# COMBINED LINWOOD/EASTERN INTERCHANGE & US 50/RED BANK INTERCHANGE FOCUS AREA ADVISORY COMMITTEE MEETING NOTES

EASTERN CORRIDOR SEGMENTS II AND III (PID 86462)

## MEETING #3 NOTES

Sept. 7, 2018

**Figure X-3A-2**  
**ADDITIONAL RAMPS AT**  
**S.R. 125 AND U.S. 50 INTERCHANGE**

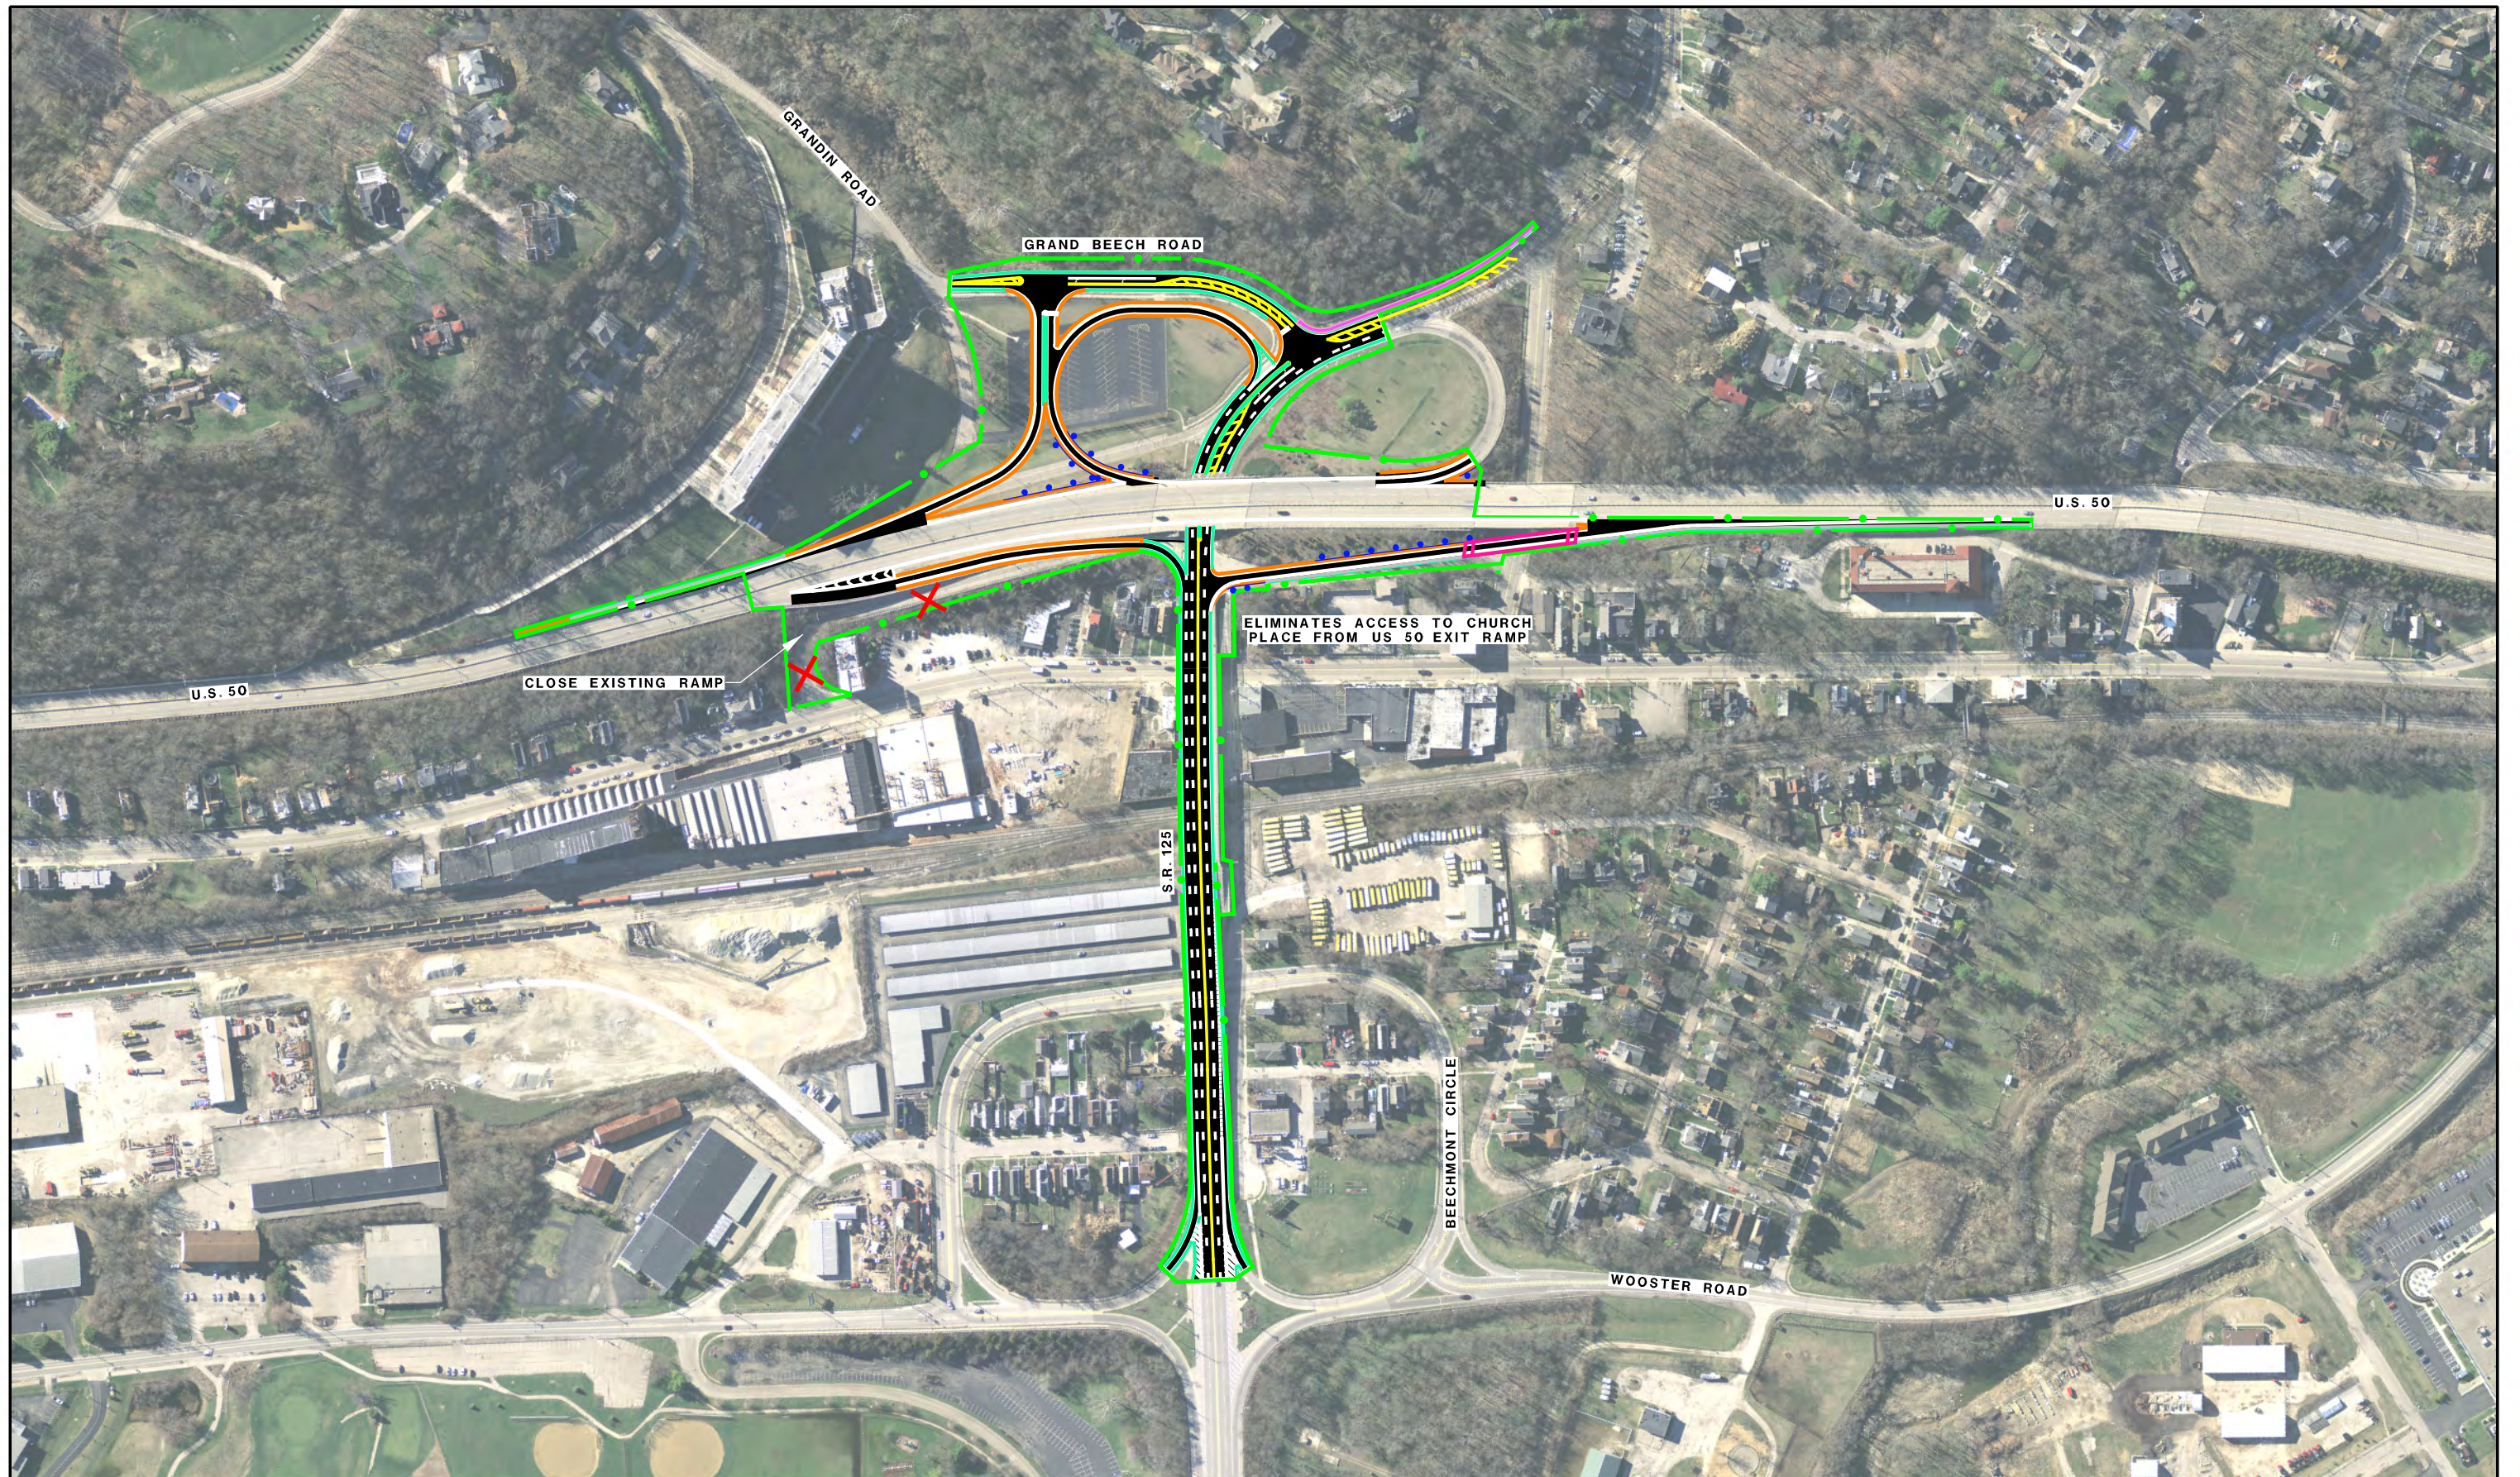
- The adjustments outlined in this concept would be made by changing current lane widths to 11 feet on the bridge; this allows the concept to be implemented without major bridge widening.
- Concept would streamline circuitous route for accessing US 50.

- Simulations show this concept would pull traffic off Wooster/Wilmer/Beechmont Circle without degrading operations on US 50; northbound and southbound travel speeds would increase during PM peak hours.
- The traffic benefit appears to be minimal compared to the expense; other alternatives offer similar traffic benefit for less cost.
- One Committee Member also expressed concern that this concept is detrimental to access within local communities with potential safety issues; drivers would need to use alternate routes that aren’t being improved.

- No further study. The concept is detrimental to local access.

### Figure EW-2

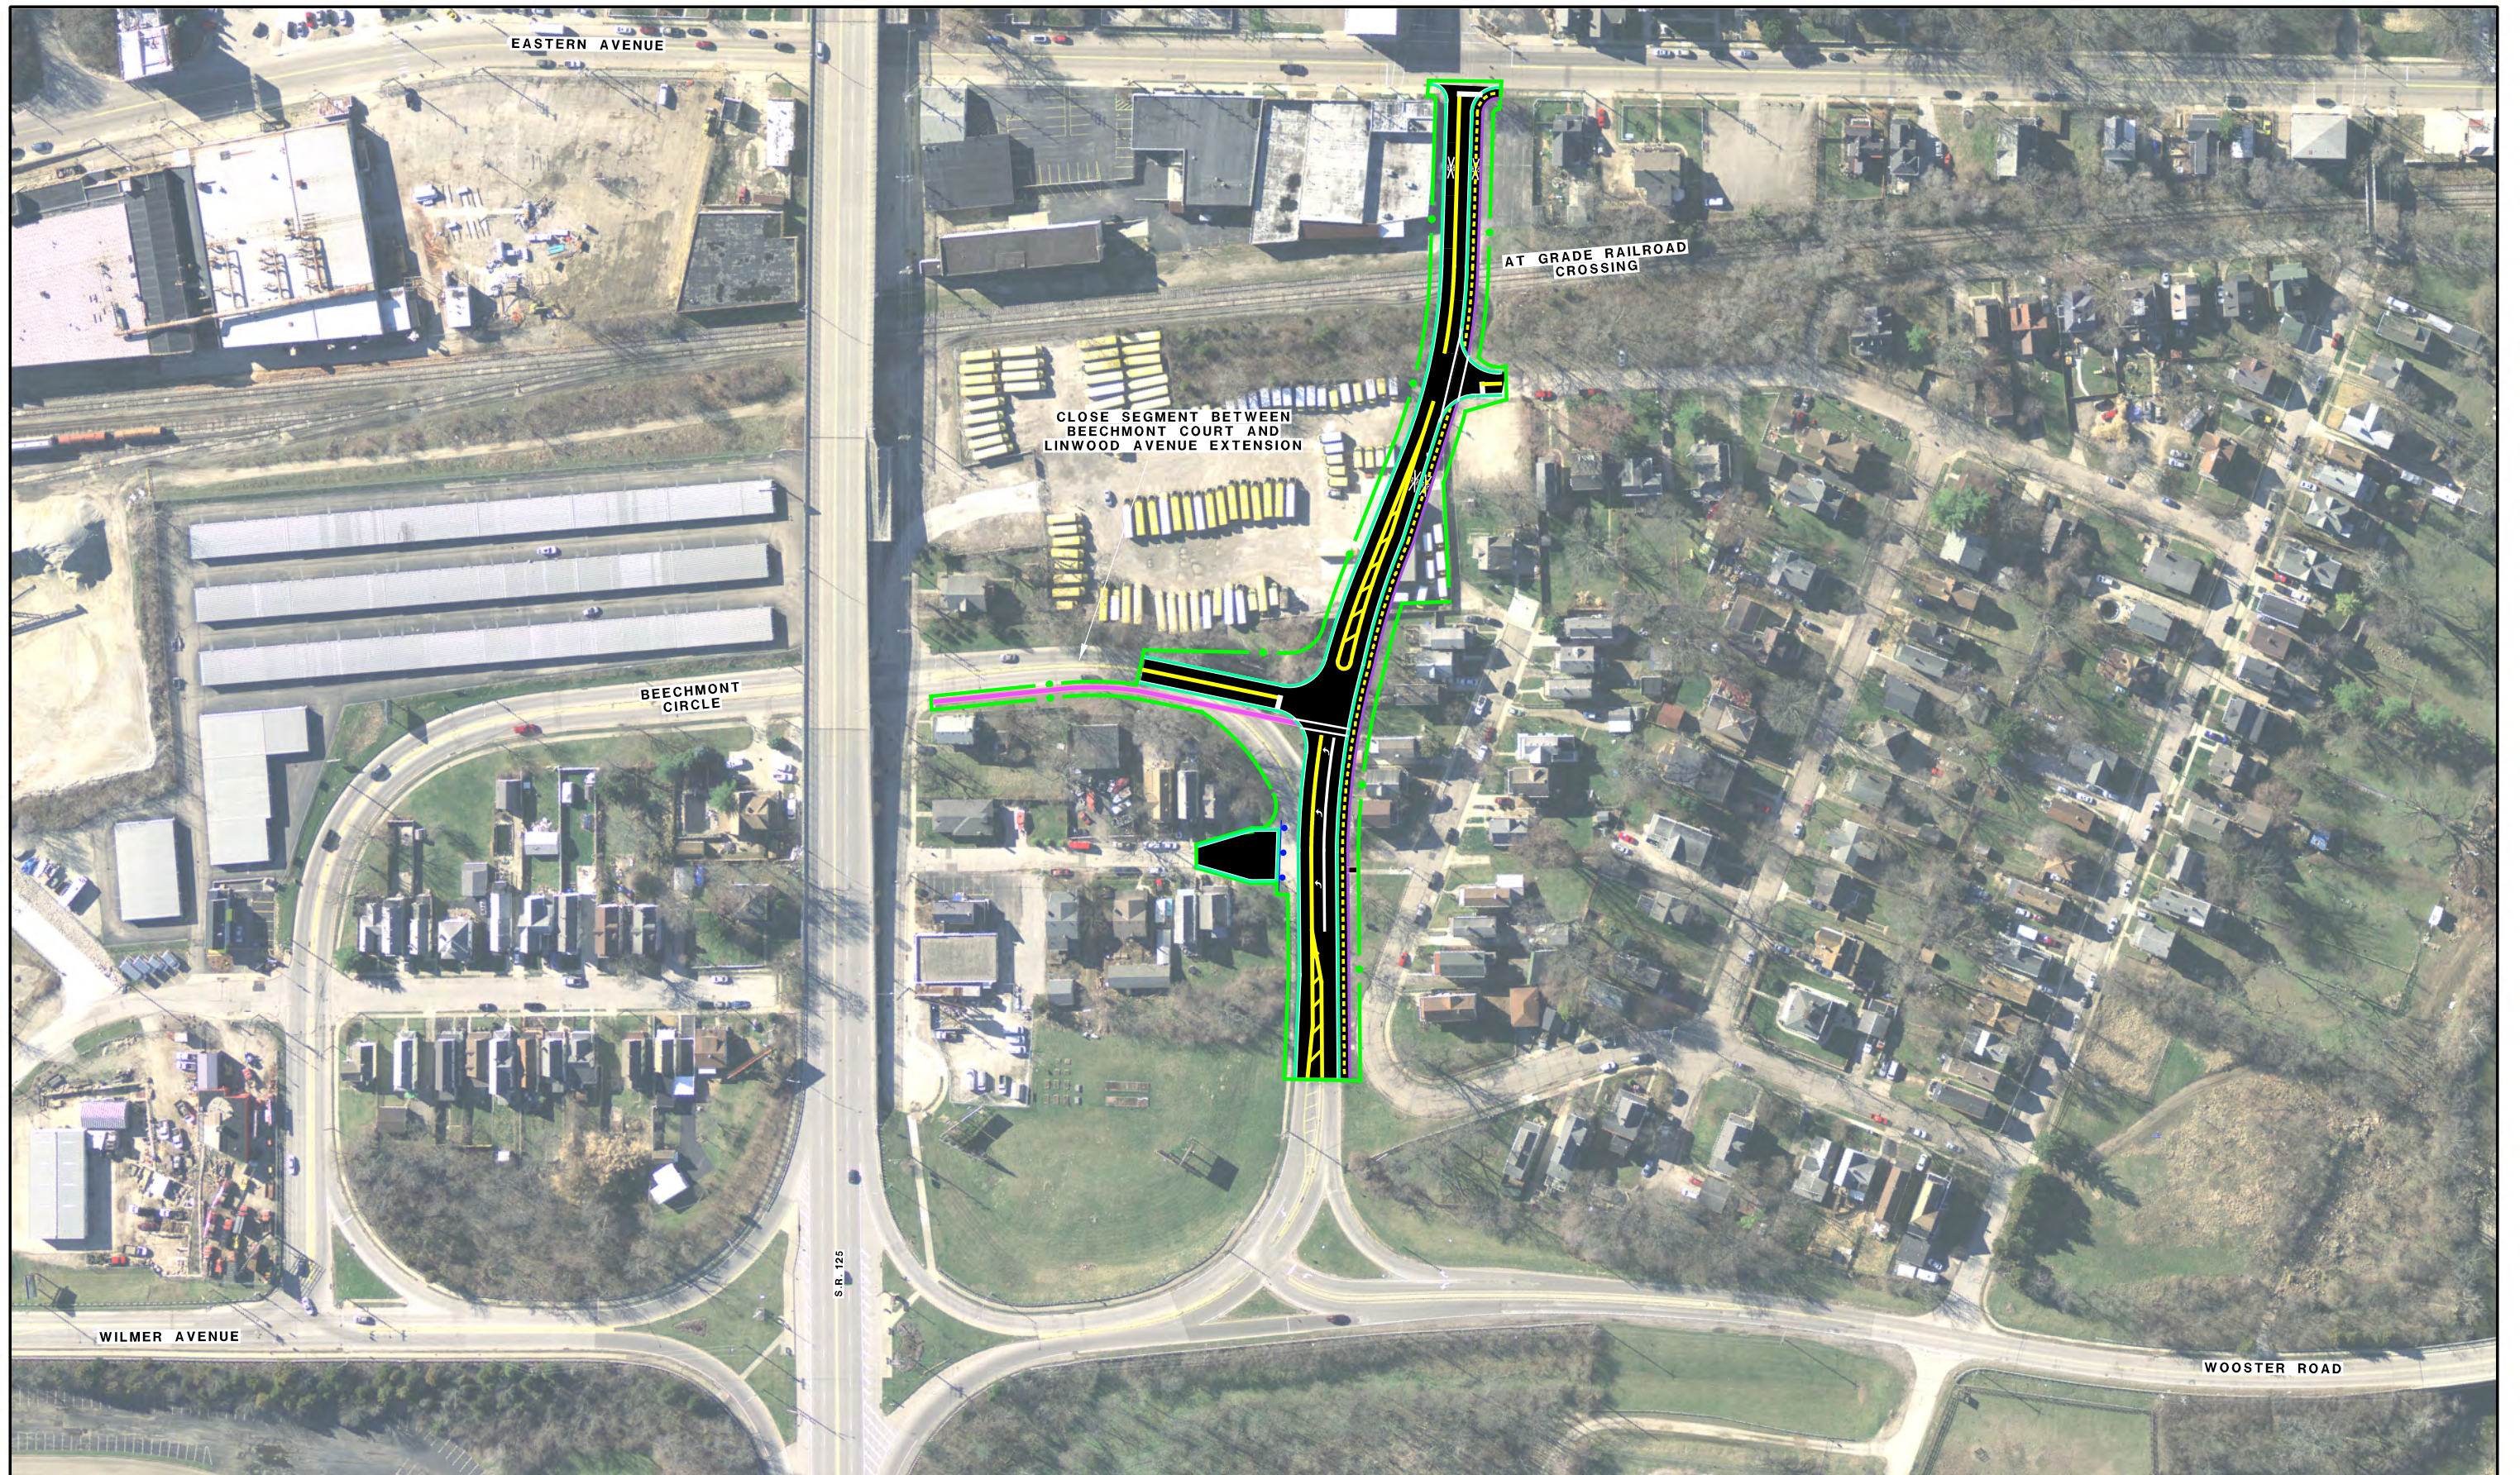
- This concept replaces/adds connectivity lost by closing the deficient ramps from Eastern Avenue to the eastbound US 50 exit ramp (concept X-3a-2); it extends Linwood to the Beechmont Circle and addresses the deficient weave on the eastbound exit ramp to SR 125.
- The concept includes a shared-use path along the east side of the road.
- There would be impacts to the bus company’s operations building and modifications to its parking lot would be needed.
- The concept would require approval of an at-grade railroad crossing and would likely require the elimination of another at-grade railroad crossing elsewhere (per railroad standard practices). If traffic volumes increase, that could be a concern.

- A Committee Member asked if a left turn onto Beechmont Circle was modeled; it was not. *[Post meeting note: ODOT’s consultant investigated traffic at this intersection and determined that even with a dual left turn, it did not function well.]*
- The City of Cincinnati considers this area to be a transit corridor.
- This concept is not intended to be a stand-alone project and would need to be implemented as part of alternatives I-29A or I-29B.

- Based on subsequent traffic analysis, this concept is not recommended for further study. However, the concept to extend Linwood is included with Concept X-2b-2a and works well.
